# UNITED STATES PATENT AND TRADEMARK OFFICE

APPLICATION NO.	FILING DATE	FIRST NAMED INVENTOR	ATTORNEY DOCKET NO.	CONFIRMATION NO.
10/585,473	07/07/2006	David Mark Allison	G40.2-13290-US01	5905

<b>Office Action Summary</b>	<b>Application No.</b> 10/585,473	<b>Applicant(s)</b> ALLISON, DAVID MARK	
	<b>Examiner</b> MICHAEL T. SCHAPER	<b>Art Unit</b> 3775

## **DETAILED ACTION**

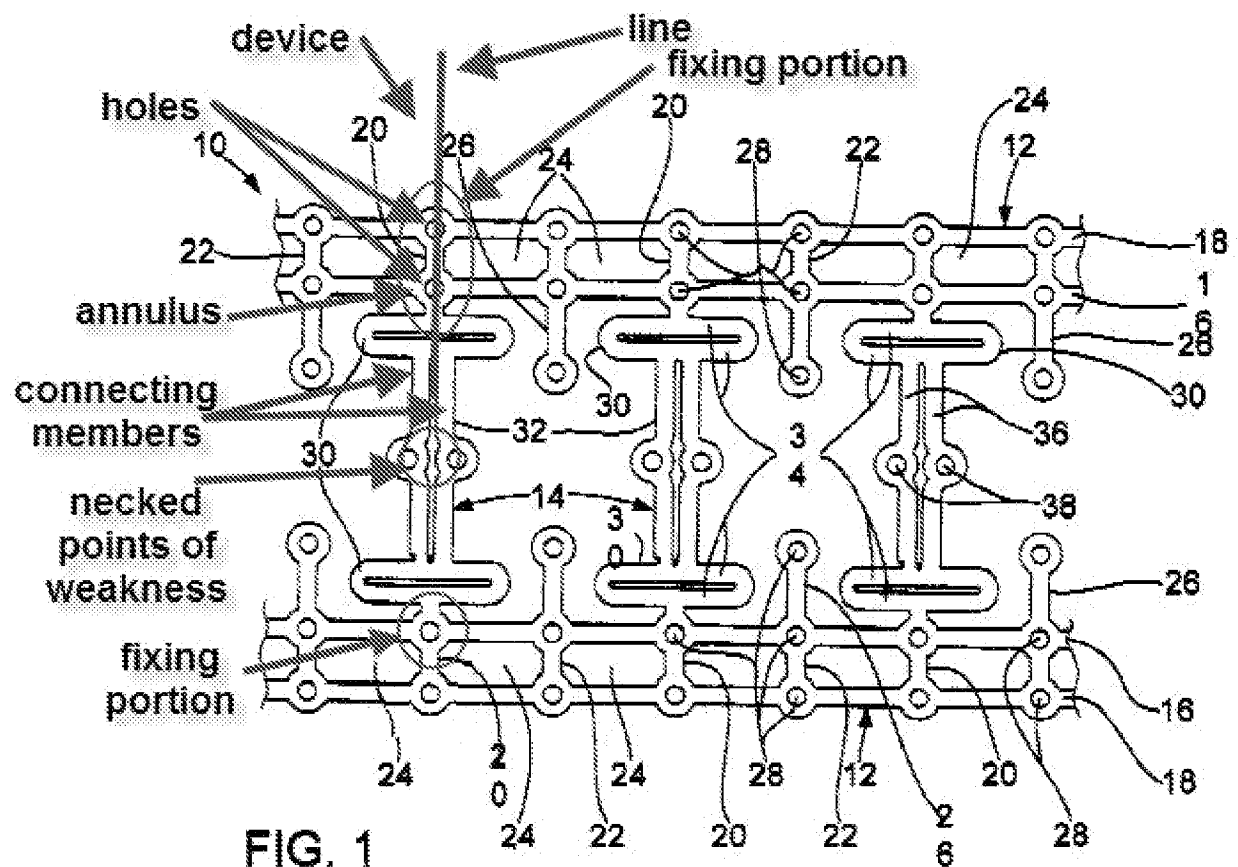
Claims 1-3, 6-9, 15, and 17-22 are rejected under 35 U.S.C. 102(b) as being anticipated by Murray (US 6093188).

As to claims 1-3, 6-9, and 18-20, Murray discloses (see FIGURE inserted above) a bone fixing device for fixing bone pieces together, the bone fixing device comprising a

pair of spaced-apart fixing portions (see above), each having at least one hole (see above) dimensioned such that a fastener capable of extending therethrough for coupling the fixing portion to bone; and, a pair of substantially rigid connecting members (see above) extending between and rigidly connecting the fixing portions, the connecting members being locatable across one or more fissures between the bone pieces and deformable while still substantially maintaining rigidity subsequent to deformation of the connecting members such that the deformation draws the fixing portions towards each other (col. 2 / line 66 to col. 3 / line 5) so that the one or more fissures are closed with the bone pieces held in compression (see FIG. 4); wherein a fixing portion comprises an annulus (see above); wherein the connecting members are deformable symmetrically with respect to a line (see above) extending through the center of the pair of fixing portions such that the fixing portions are drawn toward one another along the line; wherein the connecting members are parallel prior to deformation (see above); wherein each connecting member has at least one point of weakness at which bending of the connecting member occurs in preference to elsewhere on the connecting member (see above); wherein each of the at least one point of weakness is a necked portion of the respective connecting member (see above); wherein at least one of the fixing portions comprises at least two holes each for receiving a bone fastener (see above); wherein one of the pair of fixing portions has only a single hole; wherein at least one of the fixing portion of one of the bone fixing device is configured to be, *i.e.* capable of being, concentrically overlapped with a fixing portion of another bone fixing device in a pivotable arrangement about a bone fastener extending concentrically through the holes

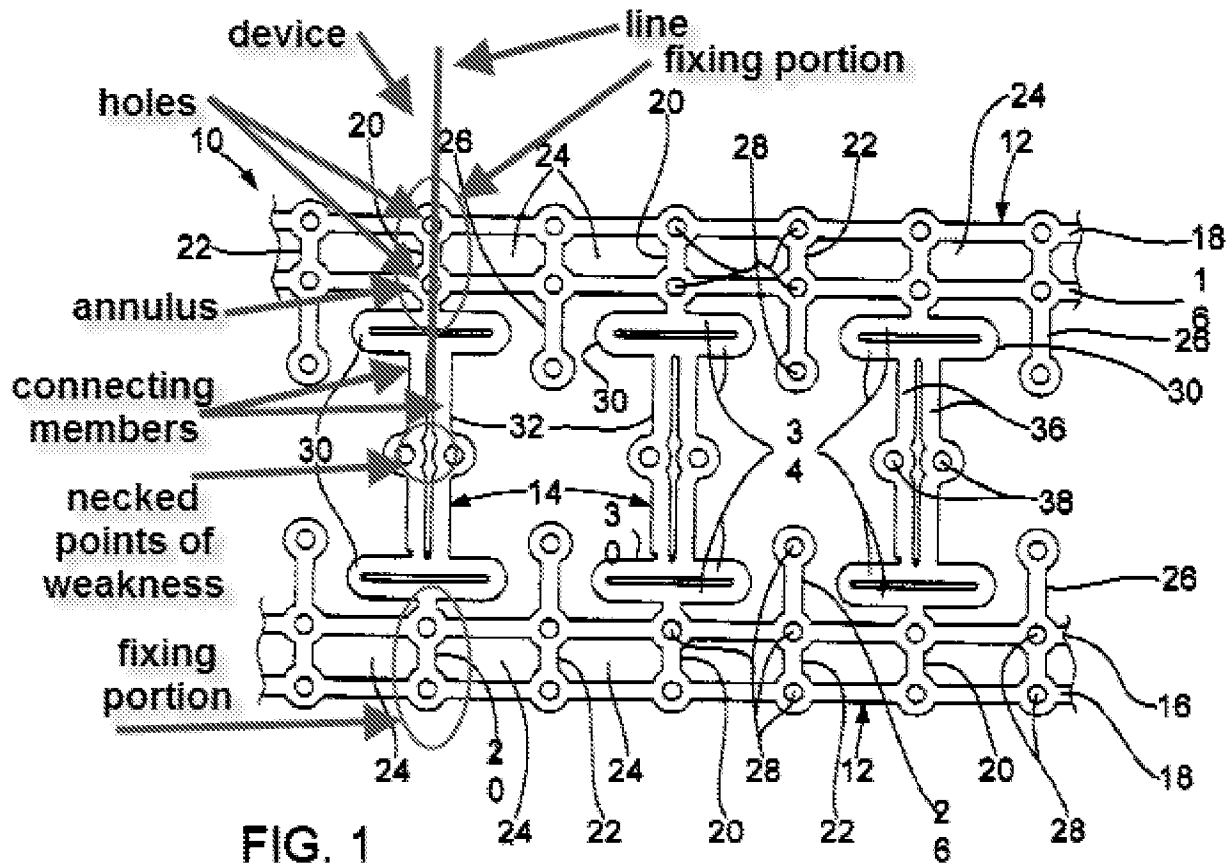
of the overlapped fixing portions; wherein the connecting members are spaced apart from each other by substantially a(n) (inner) diameter of the annulus (at necked portion).

As to claims 15 and 17, Murray discloses a method of fixing bone pieces separated by a fissure, comprising the steps of providing at least one bone fixing device (see FIGURE inserted above) having a pair of spaced-apart fixing portions (see above) each having at least one hole (see above) and in the form of an annulus (see above) being dimensioned such that a fastener can extend therethrough and a pair of deformable connecting members (see above) extending and substantially rigidly connecting between the fixing portions (see FIG. 1); fixing one of the fixing portions to one bone piece using a fastener and the other fixing portion to another bone piece using

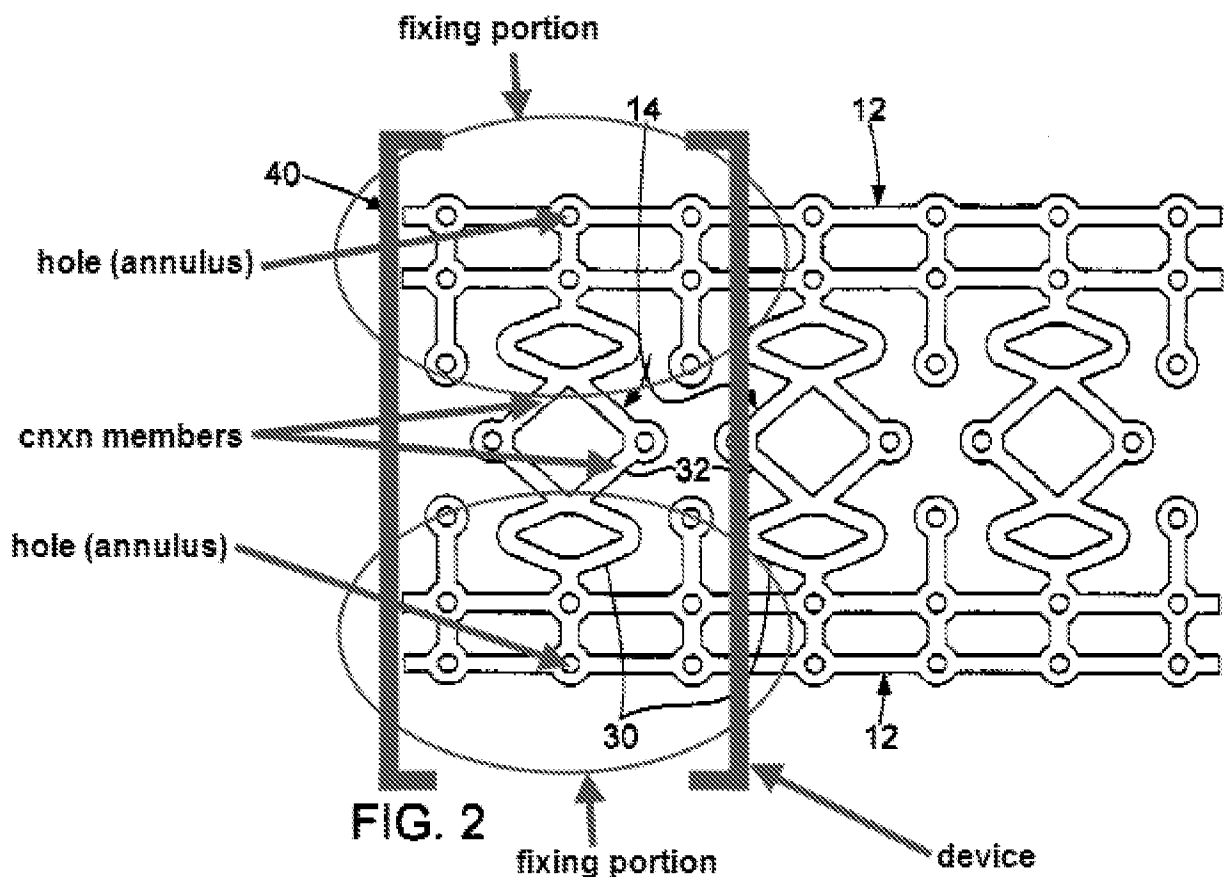
another fastener such that the connecting members extend across the fissure (col. 3 / lines 31-34); and, simultaneously deforming the connecting members such that the fixing portions are drawn together (col. 4 / lines 6-17) so as to close the fissure and hold the bone pieces in compression; wherein simultaneously deforming the connecting members in the deforming step further comprises substantially symmetrically deforming the connecting members (see FIG. 4).

As to claims 1, 2, and 21-22, Murray discloses (see FIG. 2 inserted above) a bone fixing device for fixing bone pieces together, the bone fixing device comprising a pair of spaced-apart fixing portions (see above), each having at least one hole (see above) dimensioned such that a fastener capable of extending therethrough for coupling

the fixing portion to bone; and, a pair of substantially rigid connecting members (see above) extending between and rigidly connecting the fixing portions, the connecting members being locatable across one or more fissures between the bone pieces and deformable while still substantially maintaining rigidity subsequent to deformation of the connecting members such that the deformation draws the fixing portions towards each other (col. 2 / line 66 to col. 3 / line 5) so that the one or more fissures are closed with the bone pieces held in compression (see FIG. 4); wherein a fixing portion comprises an annulus (see above); wherein the connecting members directly project from the fixing portions and there are no other projections from the fixing portions (see above, col. 1 / lines 43-44 stating that there may be only one bridge); wherein at least one of the *pair* of fixing portions is arranged to provide only a shingle coupling to the respective bone piece (see 112-2<sup>nd</sup> rejection above).

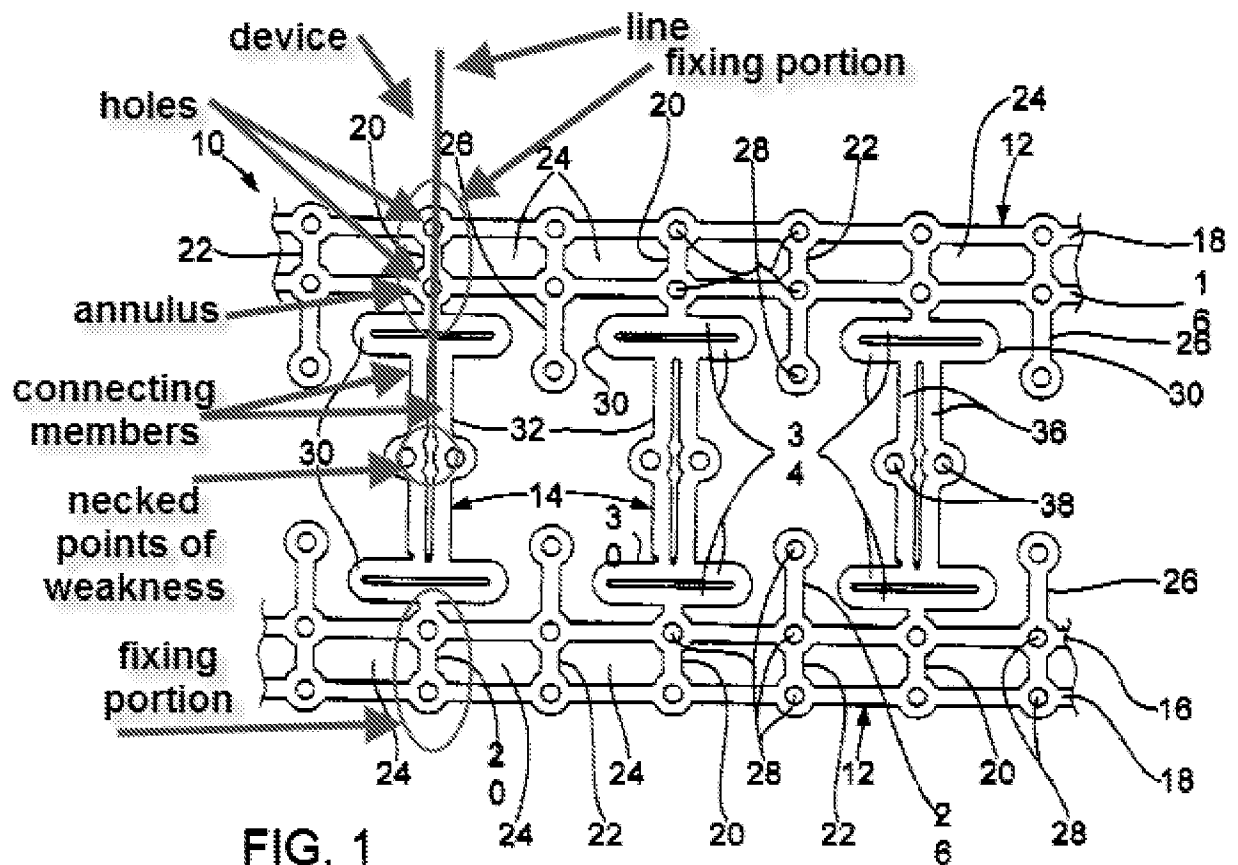
Claims 10-11 and 16 are rejected under 35 U.S.C. 103(a) as being unpatentable over Murray (US 6093188) in view of Michelson (US 2003/0060828).

As to claims 10-11, Murray discloses a bone fixing device (see FIGURE inserted above), the bone fixing device comprising a pair of spaced-apart fixing portions (see above), each having at least one hole (see above) dimensioned such that a fastener capable of extending therethrough for coupling the bone to the fastener; and, a pair of substantially rigid connecting members (see above) extending between and substantially rigidly connecting the fixing portions, the connecting members being deformable while substantially maintaining rigidity (col. 2 / line 66 to col. 3 / line 5) subsequent to deformation of the connecting members such that deformation draws the fixing portions towards each other; wherein a fixing portion is in the form of an annulus (see above).

Murray discloses the claimed invention except for a system comprising at least two bone fixing devices, wherein at least one of the fixing portions of one of the bone fixing devices is configured to be concentrically overlapped with a fixing portion of another one of the bone fixing devices in a pivotable arrangement a bone fastener extending concentrically through the holes of the overlapped fixing portions.

Michelson discloses a system comprising at least two bone fixing devices, wherein at least one of the fixing portions (148) of one of the bone fixing devices is configured to be, *i.e.* capable of being, concentrically overlapped with a fixing portion (132) of another one of the bone fixing devices in a pivotable arrangement a bone fastener (106) extending concentrically through the holes of the overlapped fixing portions. (FIG. 1, [0074]) for covering of a range of sizes of necessary plated surfaces.

At the time of invention, it would have been obvious to a person of ordinary skill in the art to have modified Murray with a system comprising at least two bone fixing devices, wherein at least one of the fixing portions of one of the bone fixing devices is configured to be concentrically overlapped with a fixing portion of another one of the bone fixing devices in a pivotable arrangement a bone fastener extending concentrically through the holes of the overlapped fixing portions in view of Michelson for covering of a range of sizes of necessary plated surfaces.
